## 1968 Corvette: Service Bulletin: Heat Damage to Engine Wiring Harness

**Bulletin No:** 68-T-25

**Date:** Feb. 19, 1968

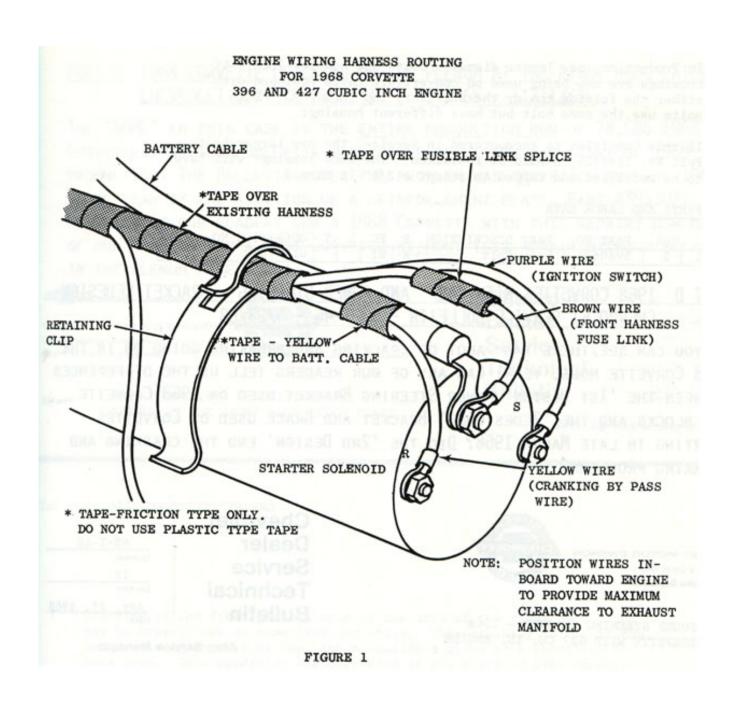
The engine wiring harness on some early production 1968 passenger vehicles equipped with either the 396 or 427 cubic inch engine may be subject to exhaust manifold heat damage harness wires are not properly routed through the retaining clip located on the starter solenoid. Reports have indicated that the yellow colored ignition or cranking by-pass wire, which attaches to the solenoid terminal closest to the exhaust manifold, is the wire most often damaged by exhaust manifold heat. To prevent damage, the wire must be routed "loop-free" through the solenoid retaining clip to the solenoid terminal.

Effective November 27, 1967, the assembly plant is repositioning and taping the wiring harness on all Corvettes with either the 396 or 427 cubic inch engine as shown in figure 1. Proper routing of the engine wiring harness through the retaining clip on all other passenger vehicles with the 396 or 427 engine is being more closely maintained at all assembly plants.

If heat damage to the engine wiring harness is encountered on subject 1968 Corvette models in the field, the harness should be taped as shown in figure 1. If harness replacement is necessary, the new harness should be similarly taped at the time of installation. All other 396 or 427 cubic inch engine passenger cars require only proper wire routing to avoid heat damage from the manifold. This wiring should be checked for proper routing at the time of new car preparation.
